Dorney Park Sidewalks Hamilton Boulevard

PROFESSIONAL STAFF CONSULTATION 2023-405

Planning Commission, September 12, 2024

SUBJECT: Dorney Park Sidewalks Hamilton Boulevard
PROFESSIONAL STAFF CONSULTATION 2023-405
REQUEST FOR PRELIMINARY/FINAL PLAN REVIEW

SHEET NO.
9 OF 13
GU-3

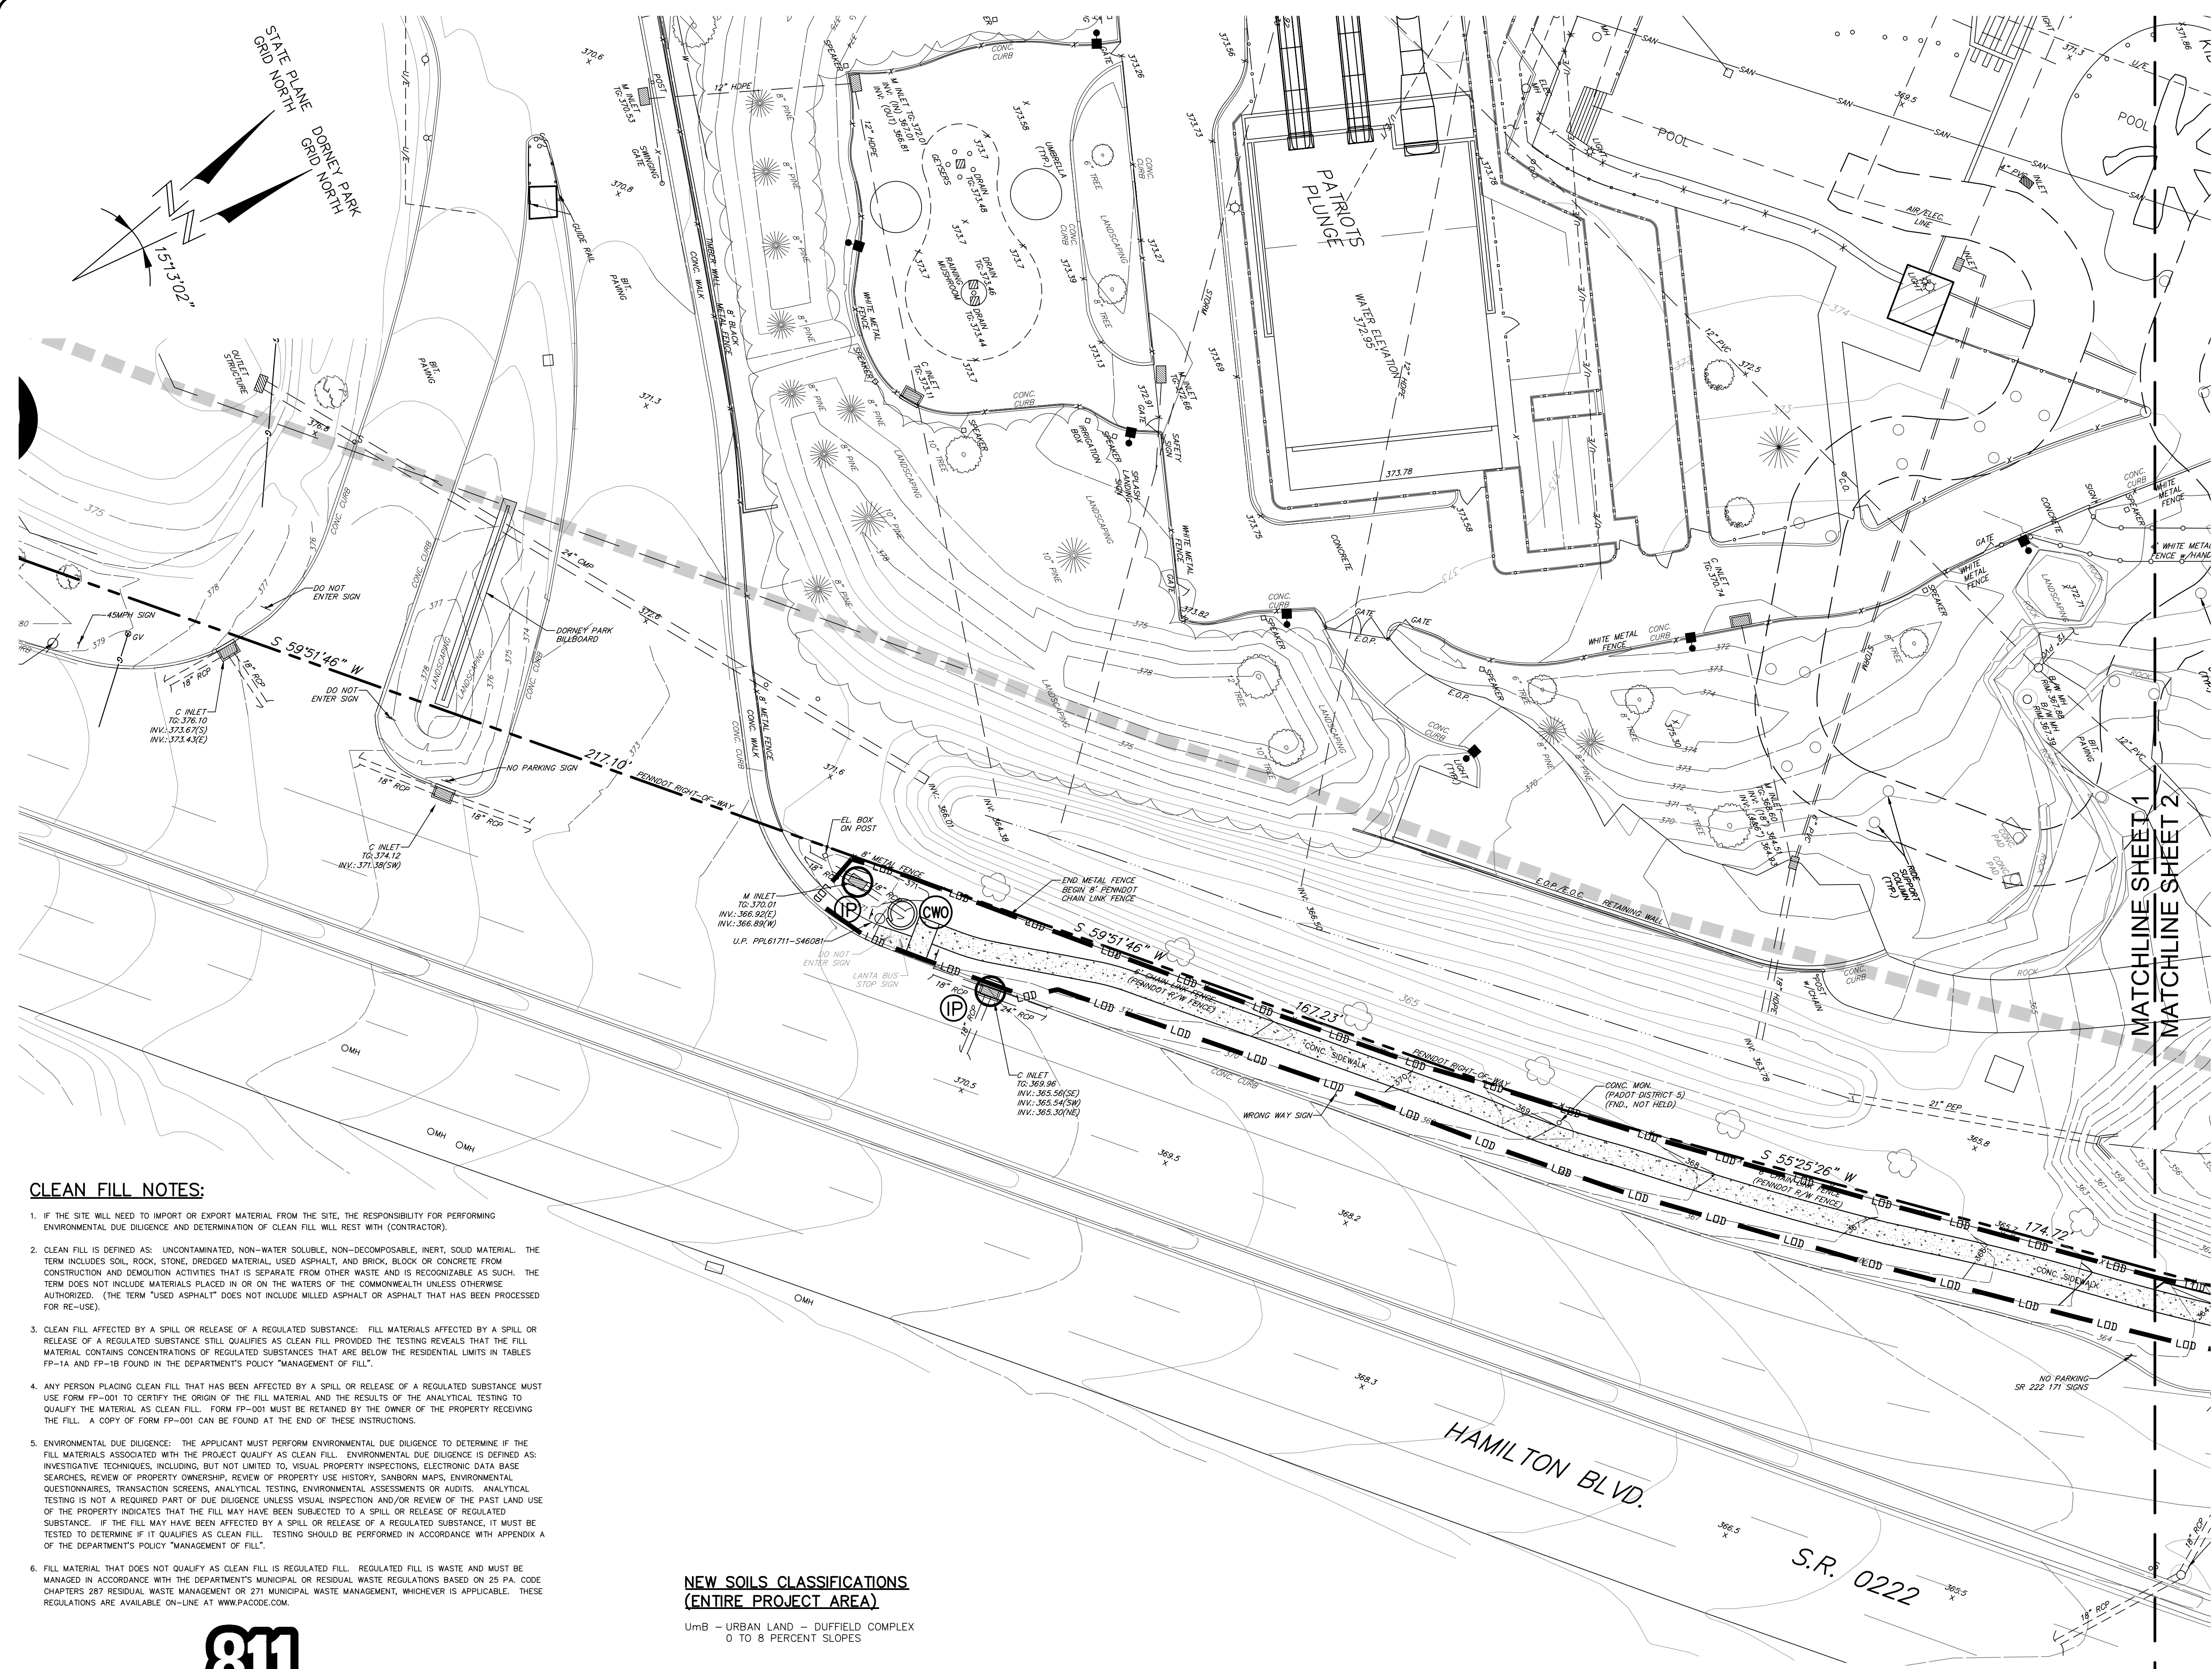
4. It appears that the longitudinal slope of the sidewalk exceeds 5% in the area north of the existing basin on Sheet GU-3. Any railings along the sidewalk and their details should be shown on the Plans;

EROSION & SEDIMENT CONTROL PLAN 1

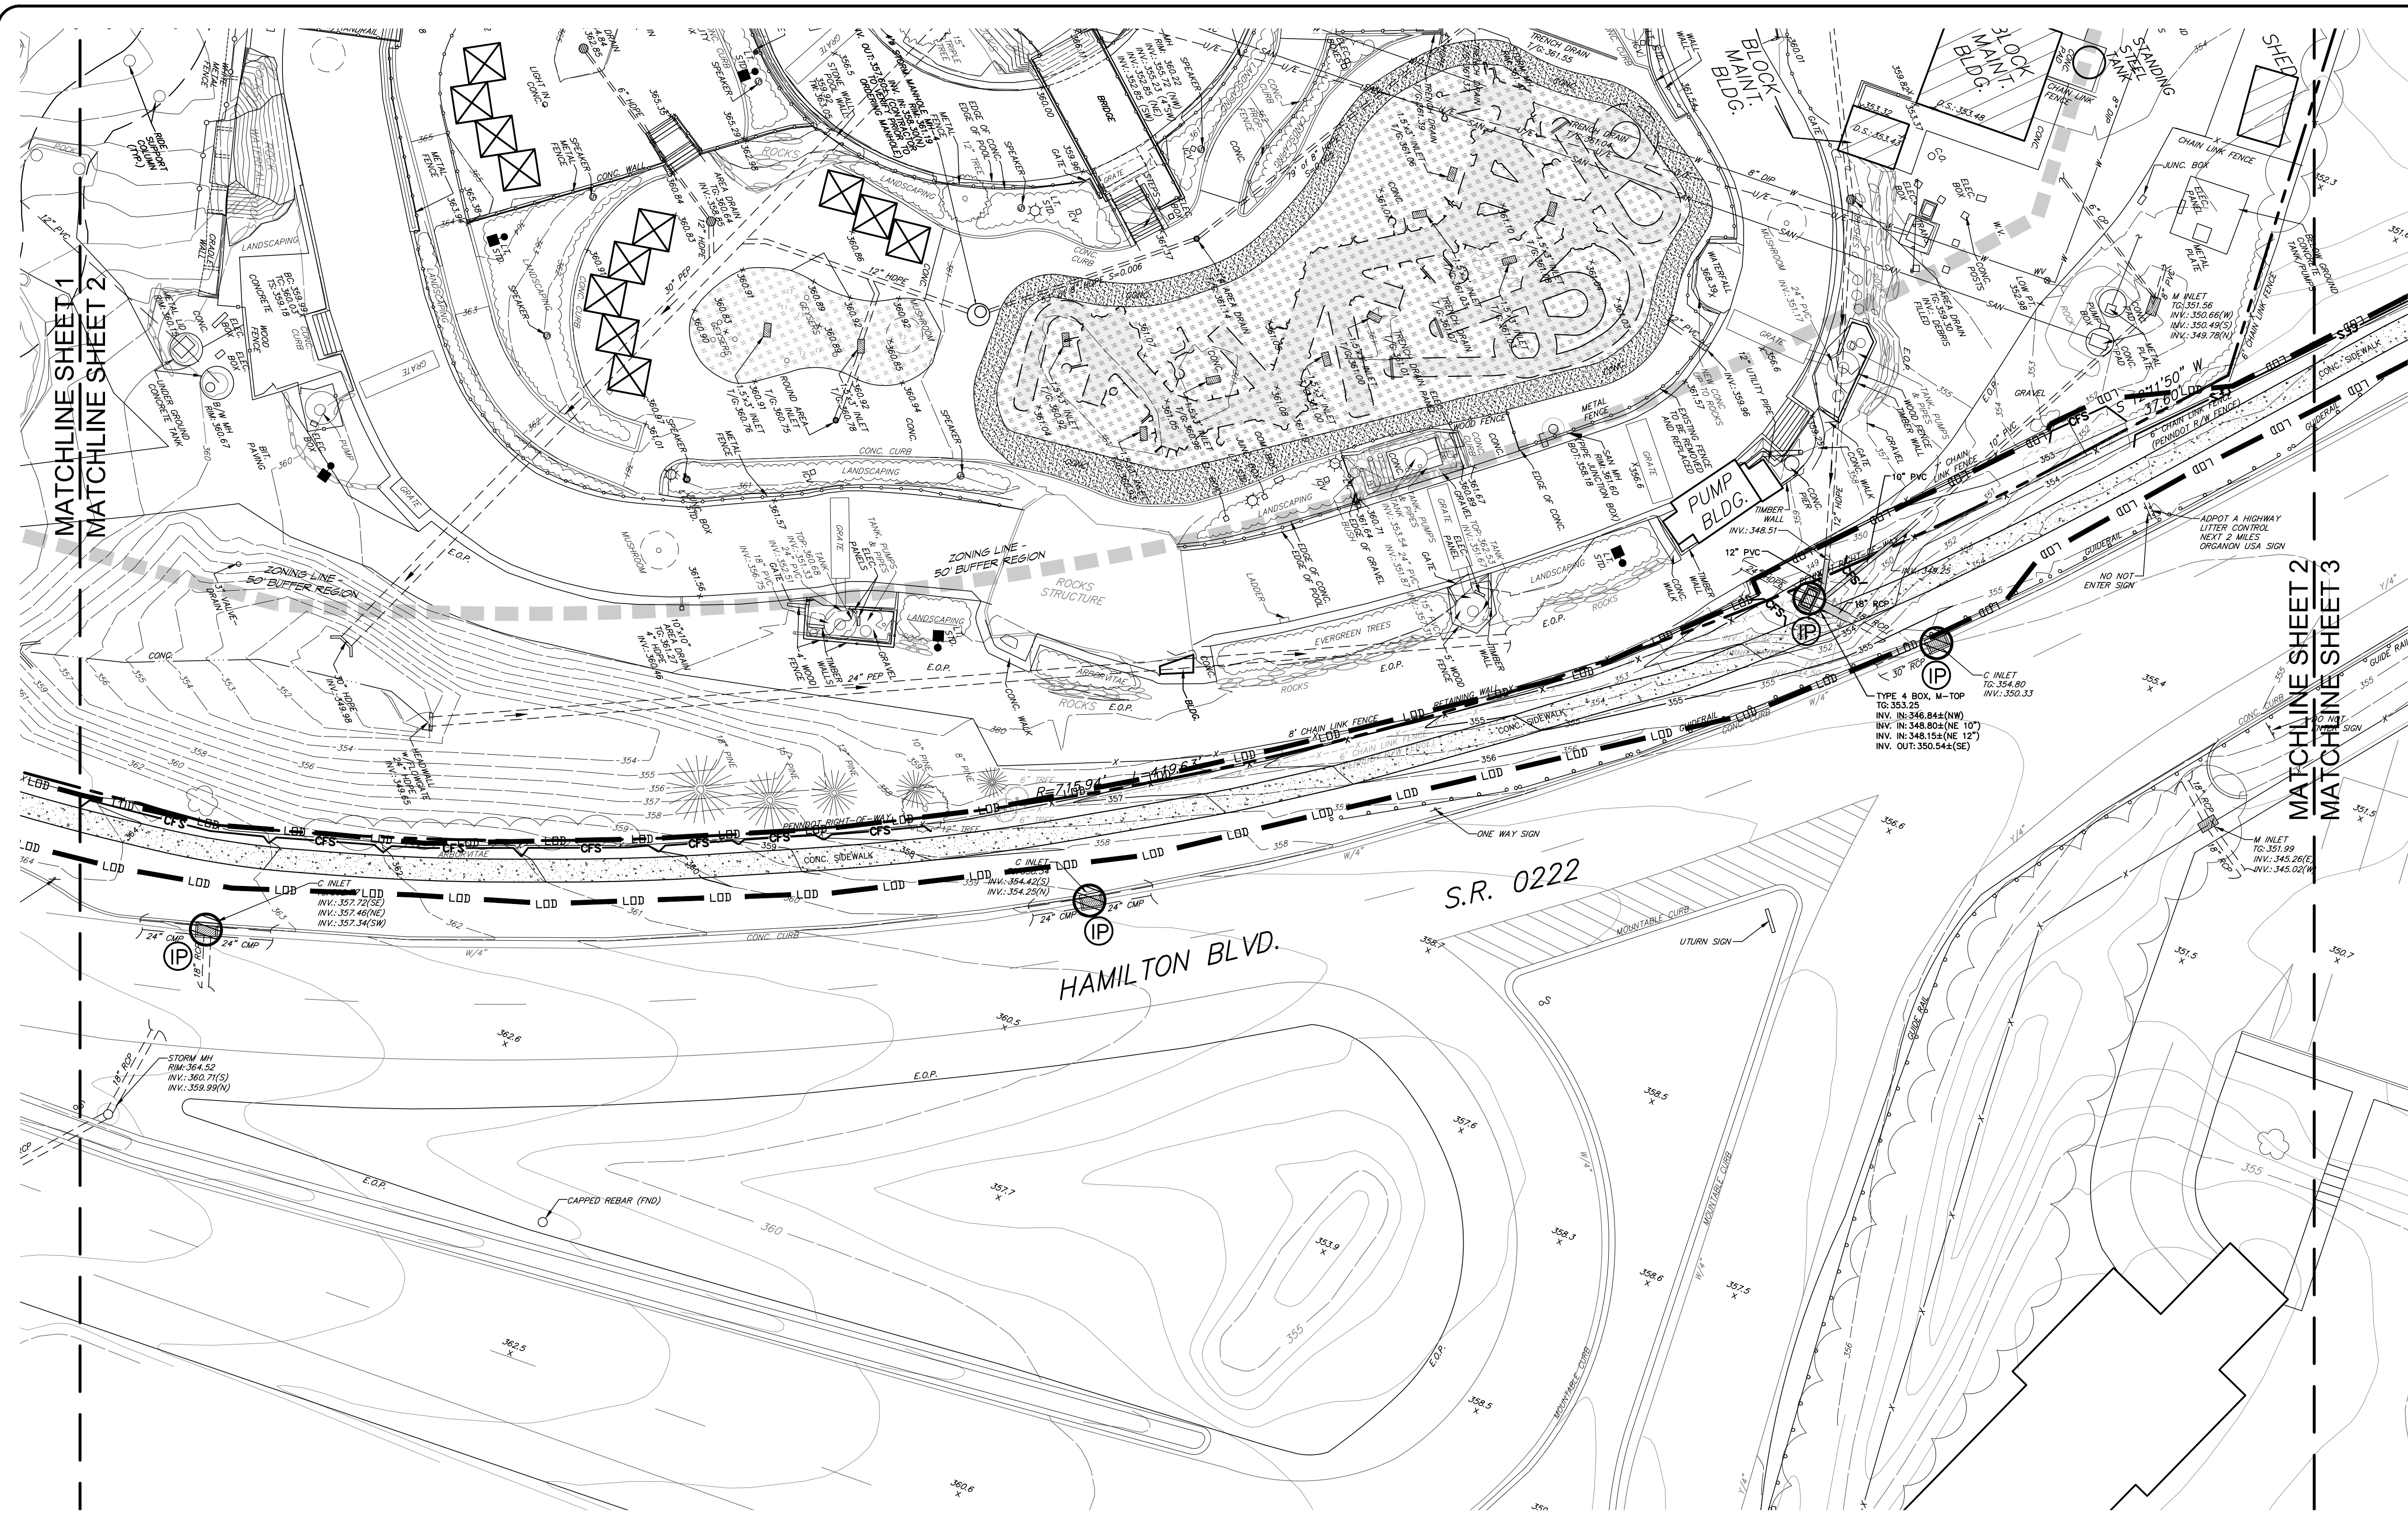
4. Grading and Utility Note 9 refers to a “wall”. Clarify the location of the wall or remove this note if it is not applicable.
5. On Sheet 10 and others, a note states, “See Plan ESD-1 for additional notes and details”. This plan is not found in this submission. Please clarify.
